**Proposal #23: 4332-05-71
 V Mishicot, CTH B
 East Twin River Bridge B-36-0318
 CTH B
 Manitowoc County**

This is Addendum No. 1, which provides for the following:

Addendum No. 1
 ID 4332-05-71
 Revised Sheet 11
 April 10, 2015

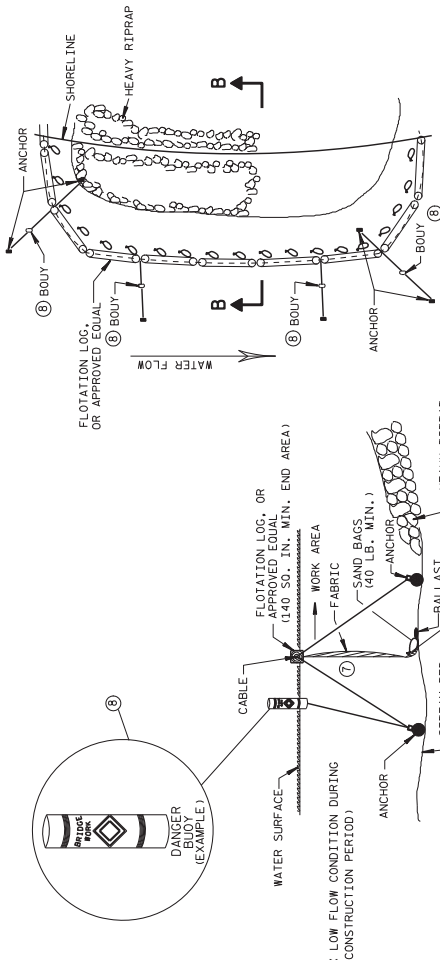
Revised Plan Sheets	
Plan Sheet	Plan Sheet Title (brief description of changes to sheet)
3	Storm Sewer and Erosion Control Details: Added turbidity barrier at bridge abutments.
7 & 8	Miscellaneous Quantities: Updated for added, deleted and revised bid items.
11	Roadway Plan & Profile: Added concrete curb pedestrian at curb ramps and detectable warning fields.
22A	SDD 8E 11-2 Turbidity Barrier: added standard detail
